Wisconsin Department of Transportation

Proposal #05: 5989-05-26, WISC 2018 139
City of Beloit, Powerhouse Riverwalk
Pleasant St. To S of Portland Ave
Non-Highway
Rock County

This is Addendum No. 01, which provides for the following:

ADDENDUM NO. 01

Addendum No. 01
 ID 5989-05-26
 Revised Sheet 7
 January 6, 2020

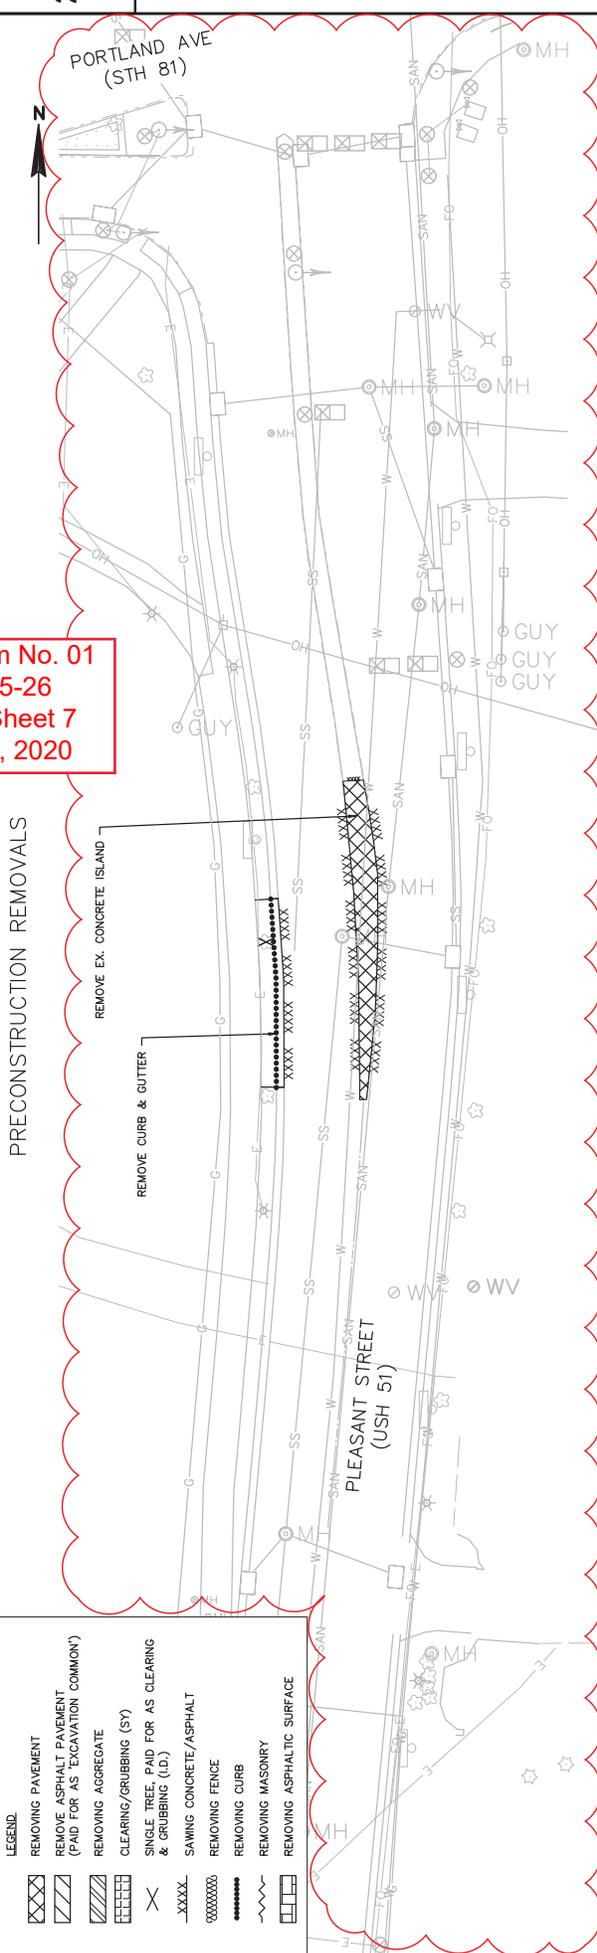
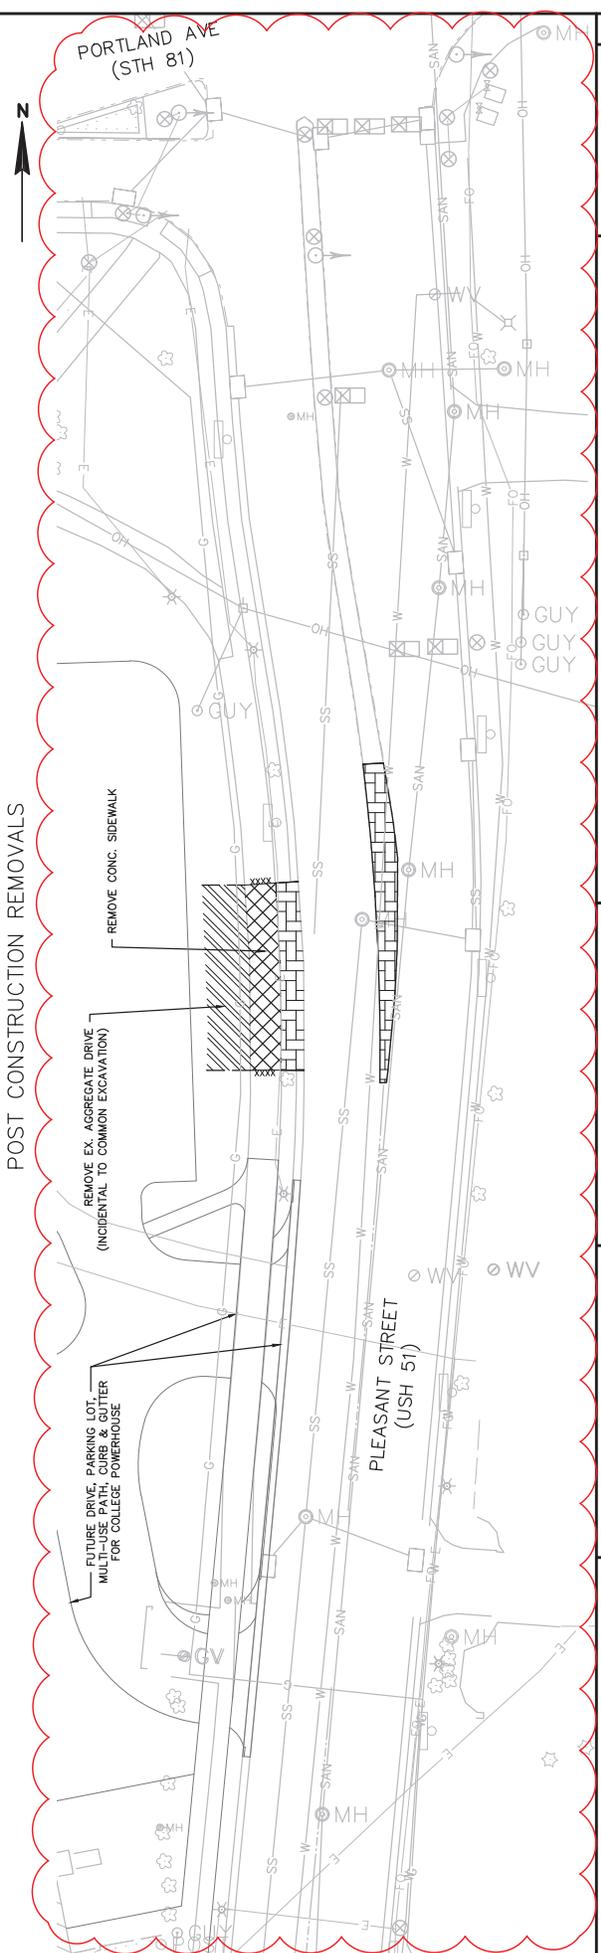
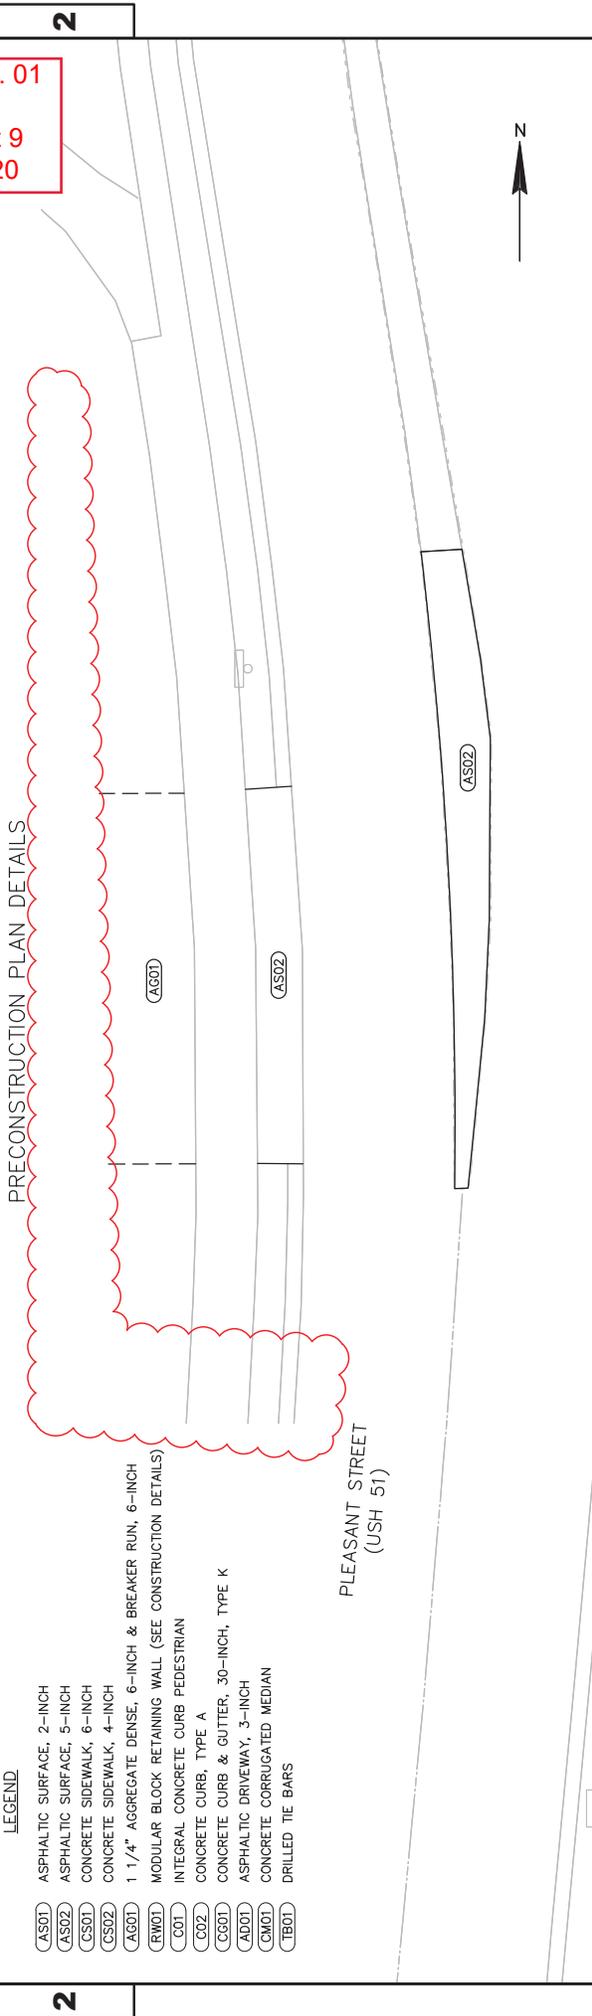
Revised Plan Sheets	
Plan Sheet	Plan Sheet Title (brief description of changes to sheet)
2	General Notes- Added the word "Gas" to Alliant Energy
7	Removal Plan-Removed "Existing Drive, Parking Lot, Multi-use Path, Curb & Gutter for College Powerhouse" and linework from Preconstruction Plan Details; revised "Existing Drive, Parking Lot, Multi-use Path, Curb & Gutter for College Powerhouse" to "Future Drive, Parking Lot, Multi-use Path, Curb & Gutter for College Powerhouse" in Post Construction Plan Details; added Alliant Gas linework
9	Plan Details- Removed "Existing Drive, Parking Lot, Multi-use Path, Curb & Gutter for College Powerhouse" and linework from Preconstruction Plan Details; Revised "Existing Drive, Parking Lot, Multi-use Path, Curb & Gutter for College Powerhouse" to "Future Drive, Parking Lot, Multi-use Path, Curb & Gutter for College Powerhouse" in Post Construction Plan Details

Addendum No. 01
ID 5989-05-26
Revised Sheet 13
January 6, 2020

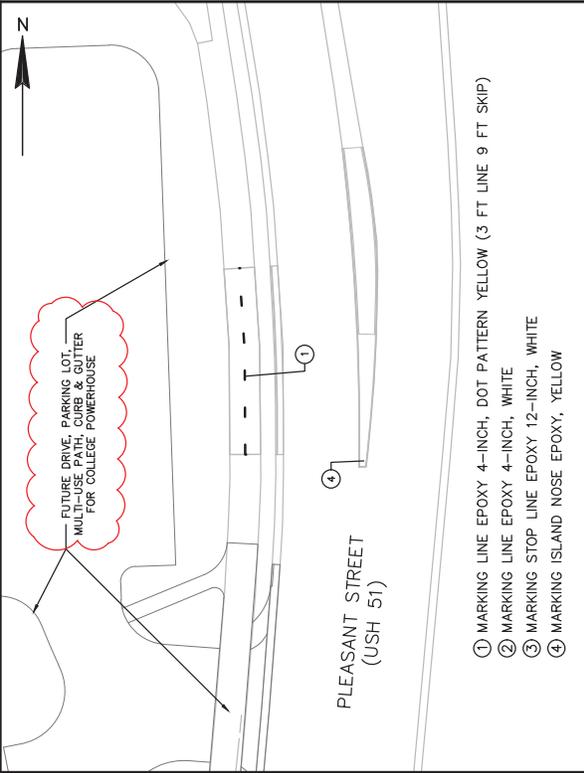
13	Permanent Signing & Pavement Markings- Revised "Existing Drive, Parking Lot, Multi-use Path, Curb & Gutter for College Powerhouse" to "Future Drive, Parking Lot, Multi-use Path, Curb & Gutter for College Powerhouse"

Addendum No. 01
ID 5989-05-26
Revised Sheet 18
January 6, 2020

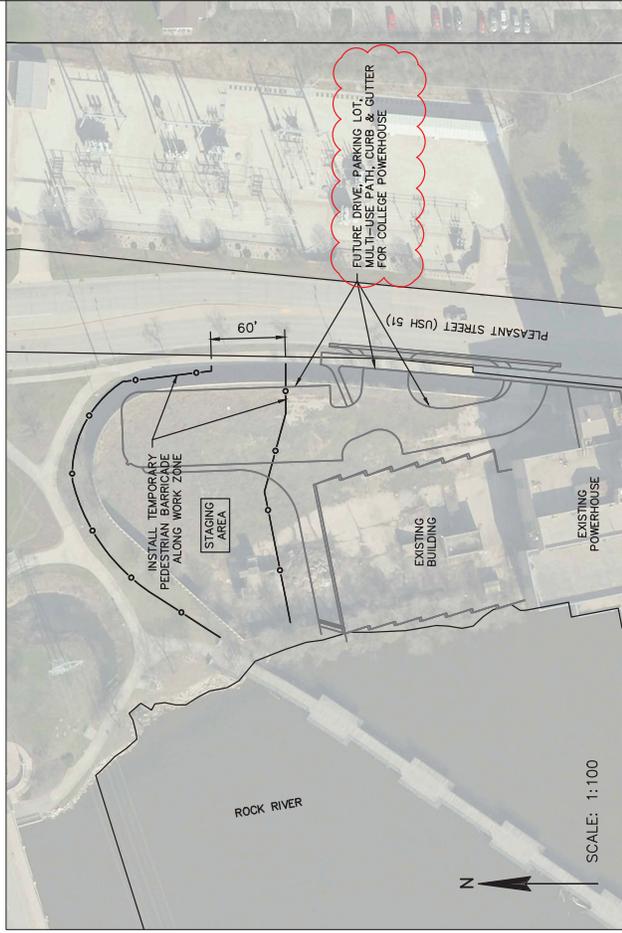
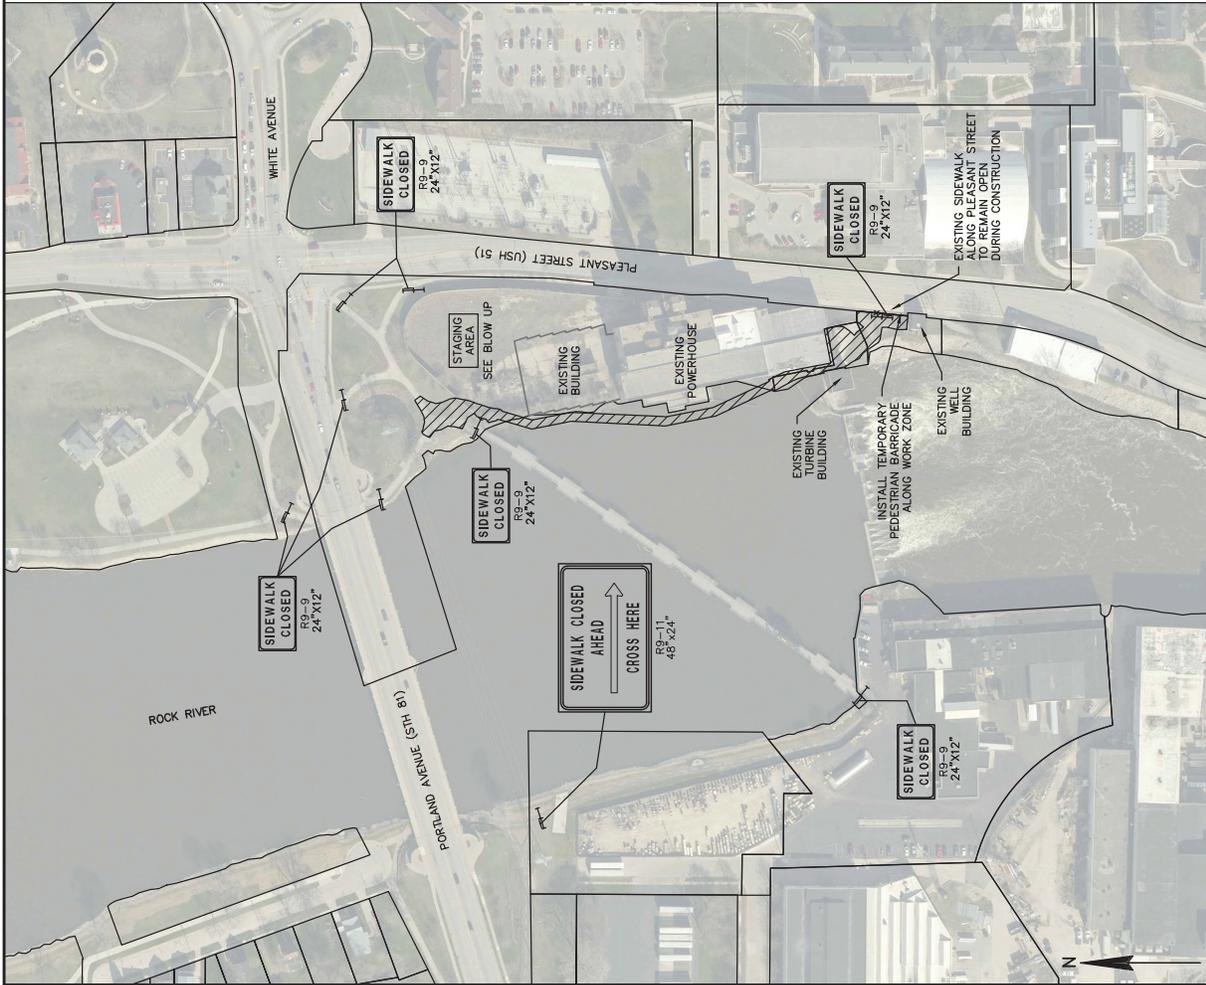
18	Traffic Control Plan- Revised "Existing Drive, Parking Lot, Multi-use Path, Curb & Gutter for College Powerhouse" to "Future Drive, Parking Lot, Multi-use Path, Curb & Gutter for College Powerhouse"
98	Structure B-53-379- Revised Note 2 of Legend: Changed Second sentence from "A325 steel" to "A449 steel"

Addendum No. 01
ID 5989-05-26
Revised Sheet 98
January 6, 2020

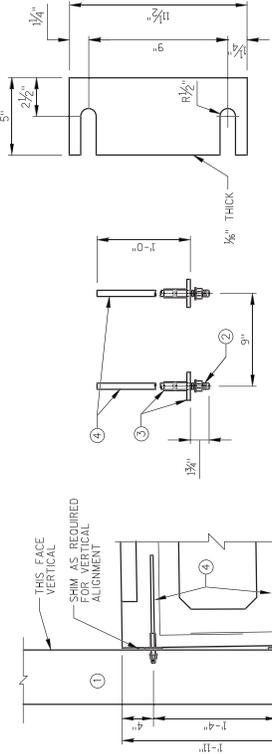
NO.	DATE	REVISION	BY
1	12/19/19	CHANGED STEEL TYPE TO ASTM A449	TR

- LEGEND**
- ① W&S POST. SEE SHEET 19 FOR RAILING DETAILS. PLACE POSTS VERTICAL.
 - ② ~~1/4" DIA. SLID WITH NUT & WASHER. FOUR REOD. PER POST.~~ (449 STEEL)*
 - ③ THREADED BAR COUPLER FOR 1/4" STUD. ACCEPTABLE PRODUCTS ARE WILLIAMS REBAR FLANGE COUPLERS BY WILLIAMS FORM ENGINEERING CORP. OR DOWEL BAR REPLACEMENTS BY DAYTON SUPERIOR. FOUR REOD PER POST. EXPOSED FLANGE TO BE GALVANIZED.**
 - ④ ANCHOR BAR 1/2" DIA. THREADED REINFORCEMENT BAR GRADE 60. FOUR REOD PER POST.**
- * SHALL BE MECHANICALLY GALVANIZED OR ELECTRO-PLATED.
** NOT GALVANIZED OR ELECTRO-PLATED.
